AS CONSTRUCTED PLANS

PROJECT NO. : 8 11 50 701
F.A. NO. : FBDNHS-306(001)
T.I.P. NO. : F-2800
COUNTY : BEAUFORT
DESCRIPTION : Pamlico River Ferry Basin Ramps ON
NC-306 Between Aurora and Both.
DIVISION NO. : TWO
CONTRACTOR : HMG, INC.
812 N. ELM ST.
GREENSBORO, NC 27401
DIVISION ENGINEER : MR. G.R. SHIRLEY, JR., P.E.
RESIDENT ENGINEER : MR. J.A. WOLF, JR., P.E.

LOCATION : N.C. 306 AT PAMLICO RIVER FERRY
 TYPE OF WORK : GRADING, PAVING, BULKHEAD REPLACEMENT,
 RECONSTRUCTION OF FERRY RAMPS, AND STRUCTURES

47 4737

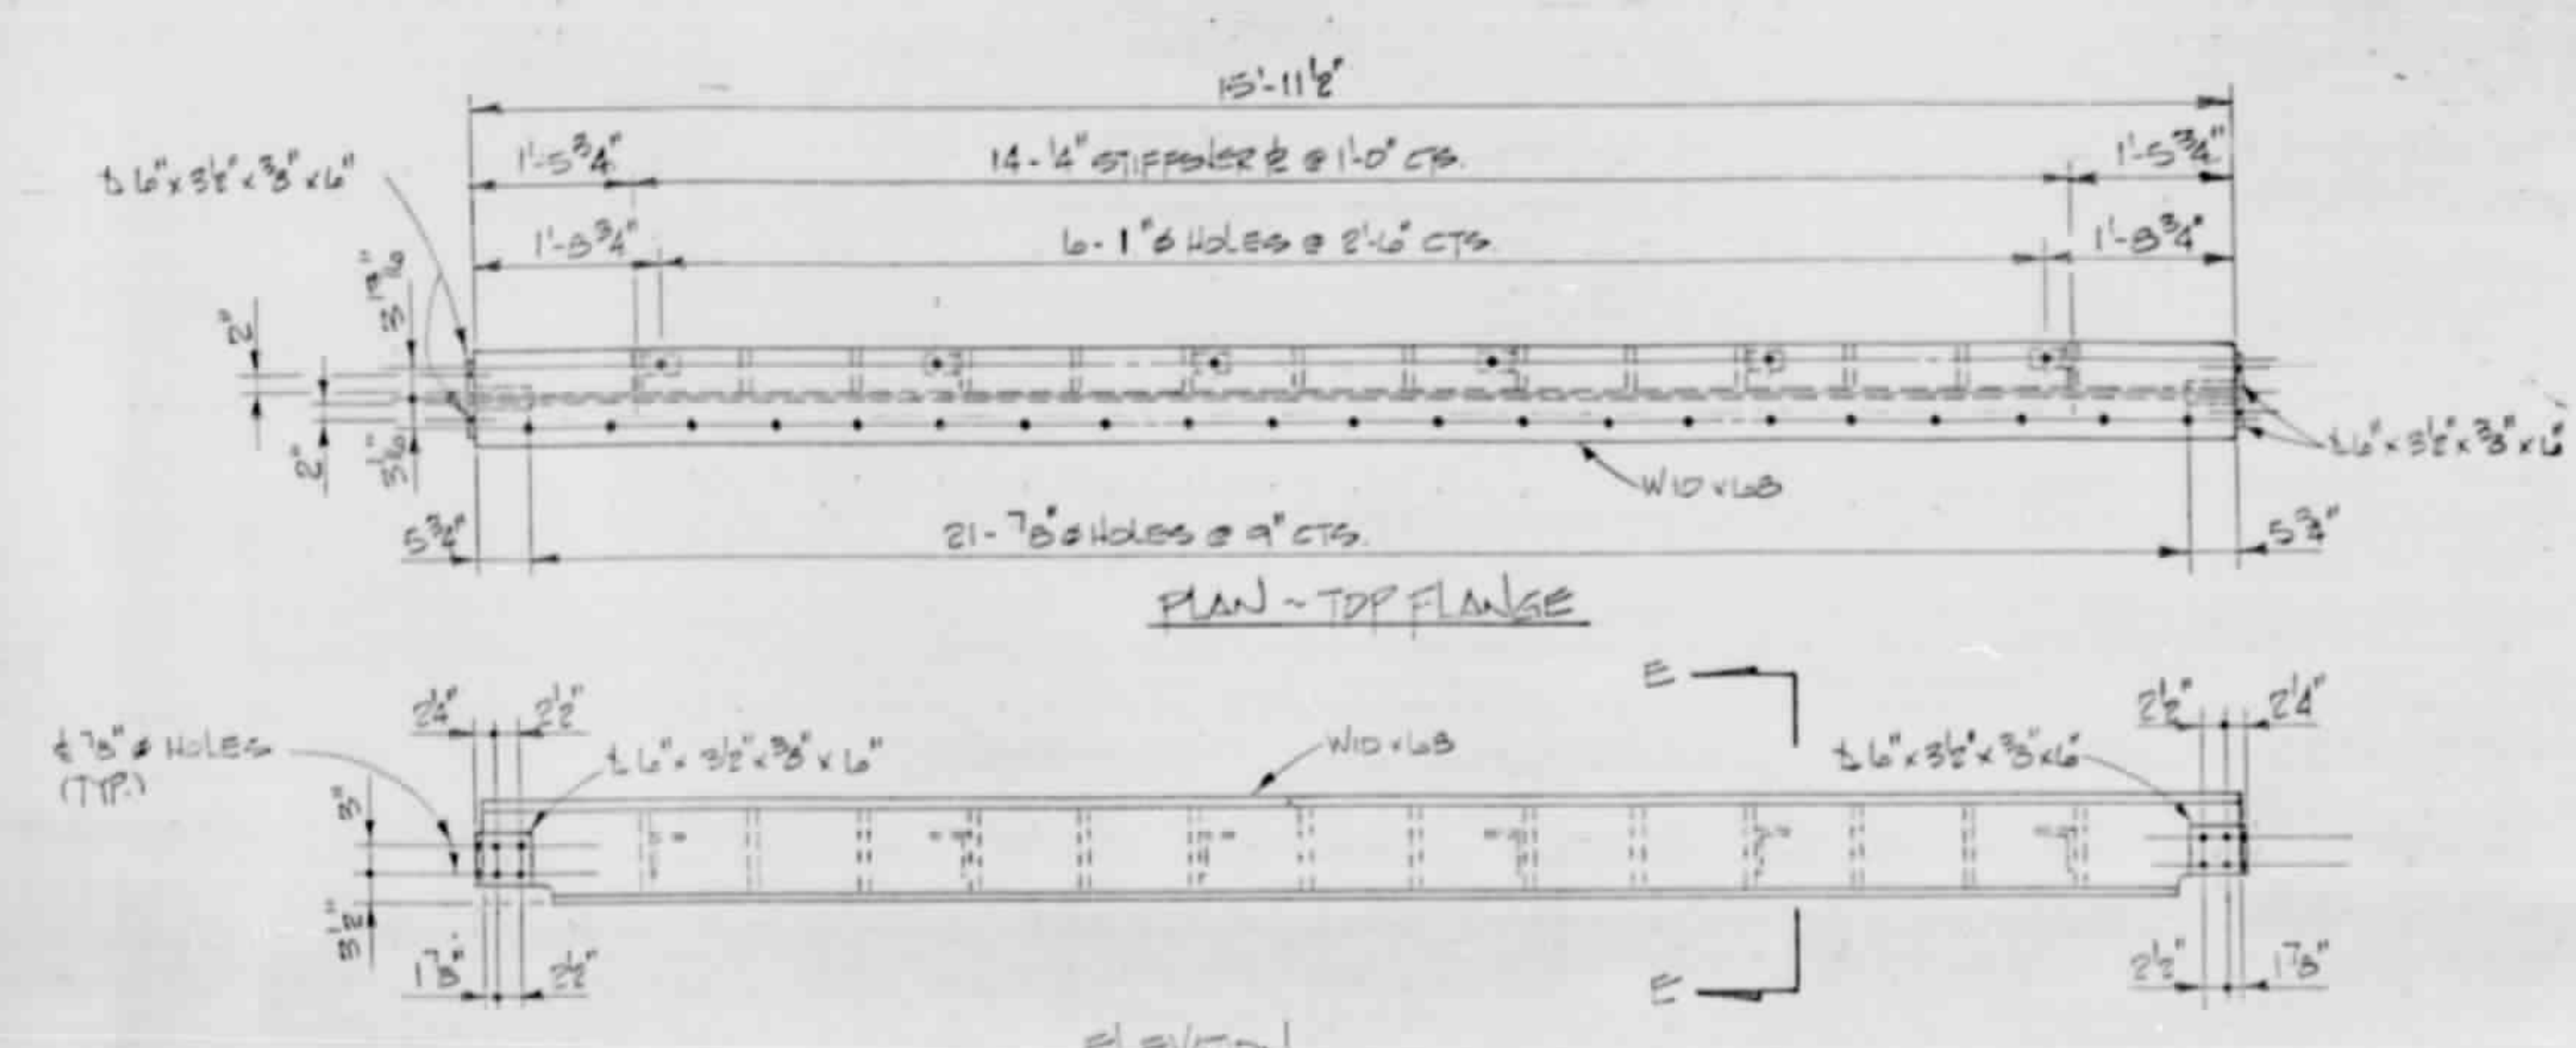
Rev No. 1 Revised right hand side of Plan and Elevation of FB4 To Show Proposed Plate. Drawn By: FAM / By: PEK

DETAIL - "L"

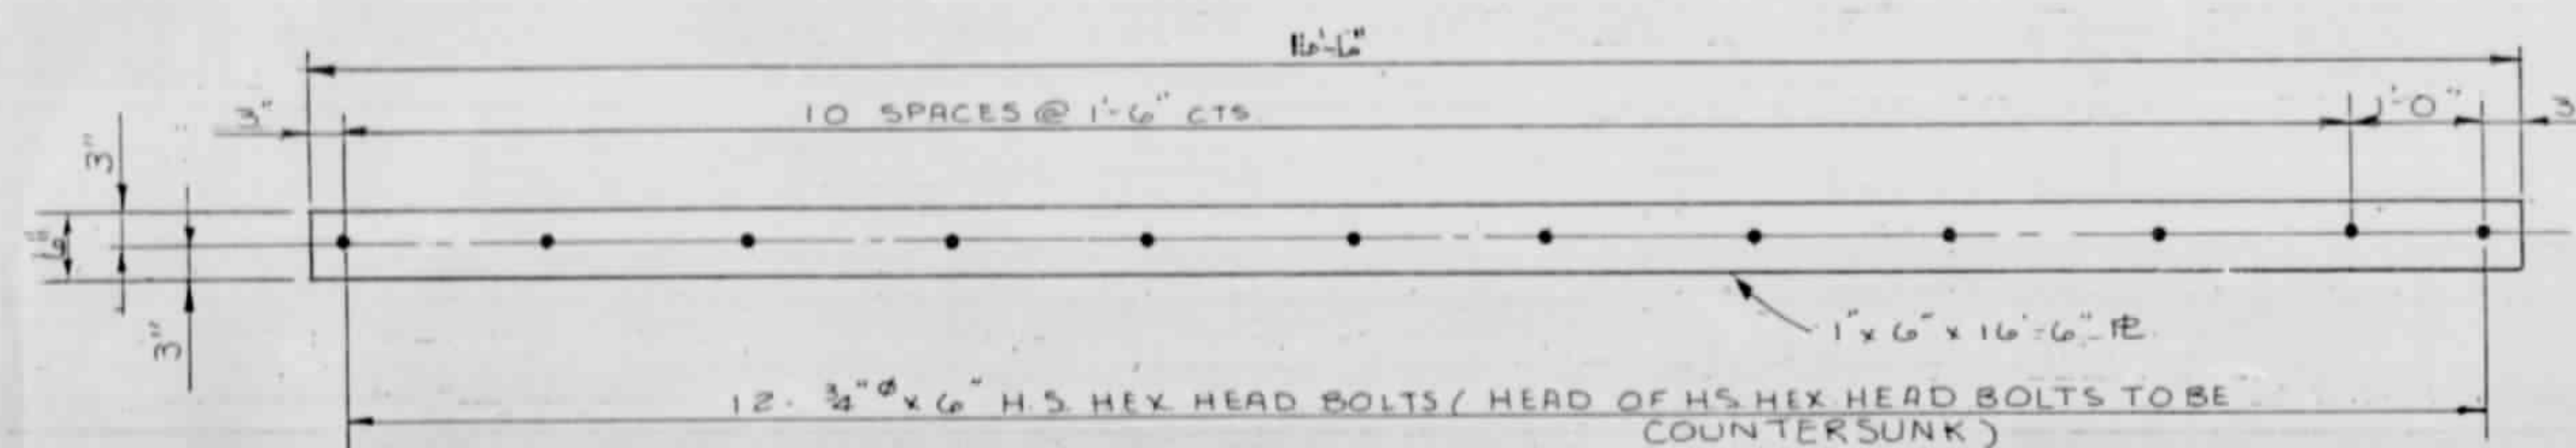
Rev No 1: Added 3/8" Holes in Top Flange and Deleted 3/8" ϕ Holes in Bottom Flange of HP12x53 in Detail "L".
By: FAM / By: BEK
